# Staff Report Number: CSOPS.24.043

125 Peel Street South Servicing  
Public Information Centre Follow-up  
Bill Abbotts  Thornbury

# Curb comparisons

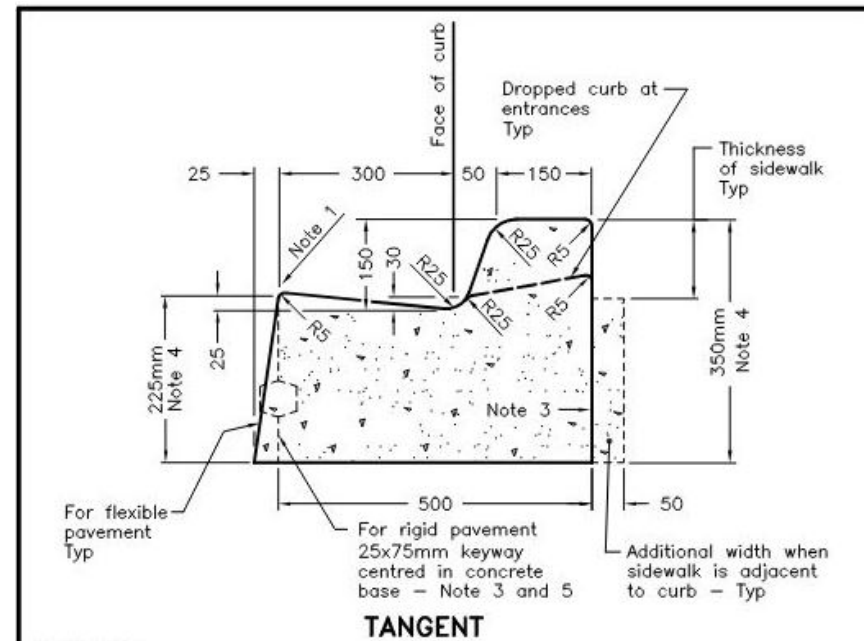
We hear a lot that barrier curbs are required to protect pedestrians on sidewalks.

There is much more risk for vehicle cyclists collisions than vehicle pedestrian collisions with either barrier or semi mountable curbs. The semi mountable curbs at least give cyclists an escape option to reduce their risk. Semi mountable curbs also allow for mobility devices and strollers or carriages to have across street access. If you live on the opposite side of a street with one sidewalk you need to be able to get your mobility device or child carrier to the sidewalk - very difficult with a barrier curb.

Another reason for barrier curbs is snowplowing. I maintain the safety of vulnerable cyclists should trump snow plowing with streets designed for people not just snow plows.

Semi mountable curbs can be a decision of council. They have been previously.

## PEEL ST. SOUTH ALTERNATIVE NO. 2: FULL URBANIZATION

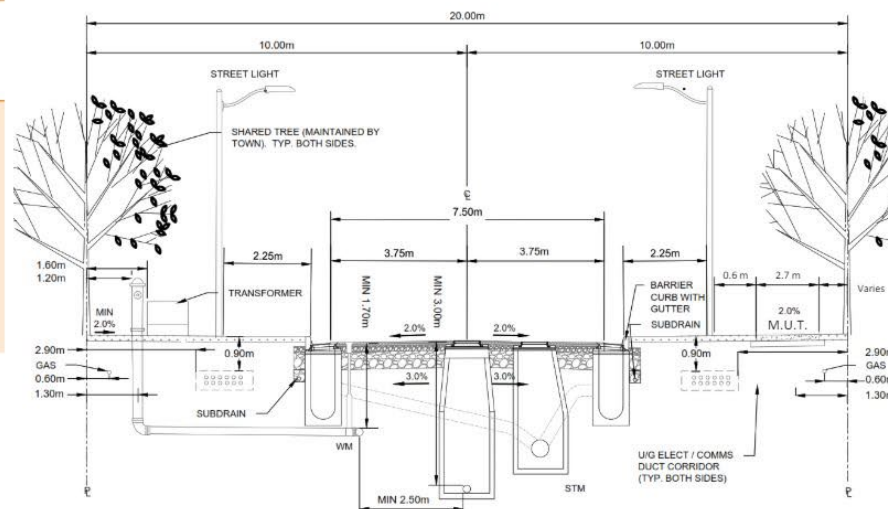
**Regarding CSOPS 24.043, I respectfully still maintain the staff “aligns” assumptions and advantages/disadvantages in the report are severely flawed.**

The Transportation Master Plan, of which I was a committee member, does not promote Multi Use Trails in urban settings. OTM Book 18 backs this up.

The proposed MUT on the Peel St N project is a dangerous mistake just waiting for accidents to happen if it is constructed as proposed. I stand by this statement.

Please do not keep repeating this unsafe mistake. A MUT was mentioned for Bay St E with 15+ driveways between Elgin and Grey in the Bay St E PIC. The consultant stated multiple times during that PIC this was a starting point that council could adjust.

***Direct staff to pursue a profile similar to the Louisa St photo and the rest of Thornbury West, High Bluff Lane, Timber Lane etc, including painted lines and semi mountable curbs.***

# Engineering Standards

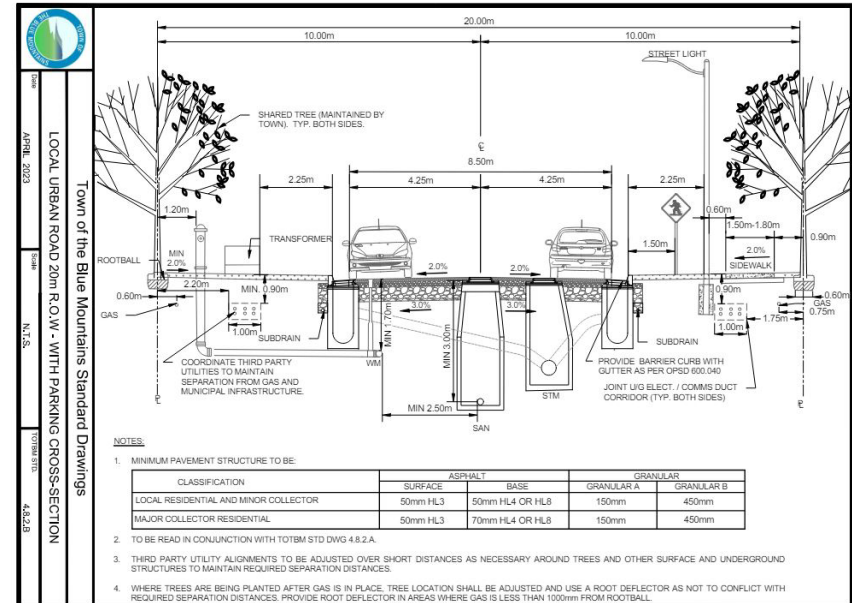
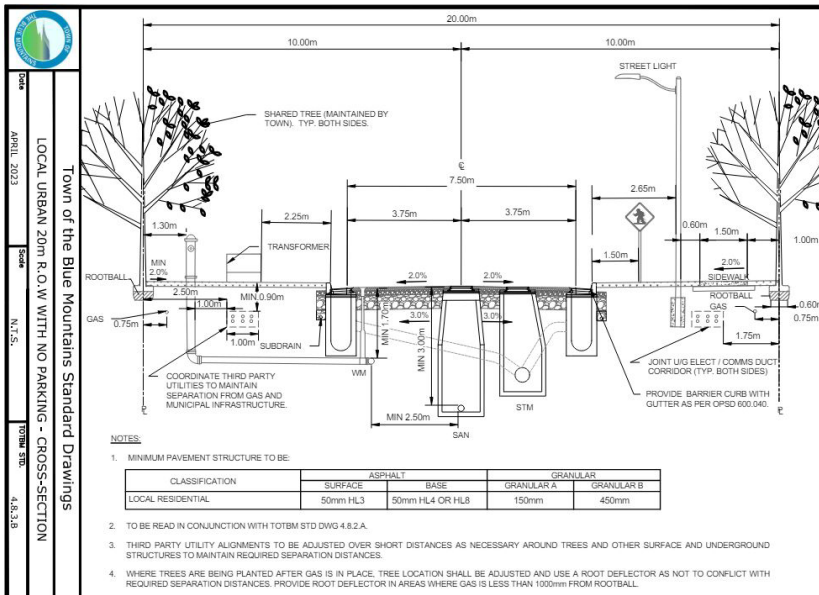
The TBM Engineering Standards do not include a Multi Use Trail (MUT) in any profiles or descriptions I could find, so why is it being promoted as a standard?

The standard I am requesting to be used is the 8.5 metre pavement with 3 painted lines to give 3 metre vehicle lanes and 1.25 fog lines (active transportation shoulders) with a 1.5 metre sidewalk on one side.

I don't see any other proposed traffic calming measures in the proposed profile, and even worse the 3.75 metre lane is almost the same width as on Highway 26 for 80 kph speeds.
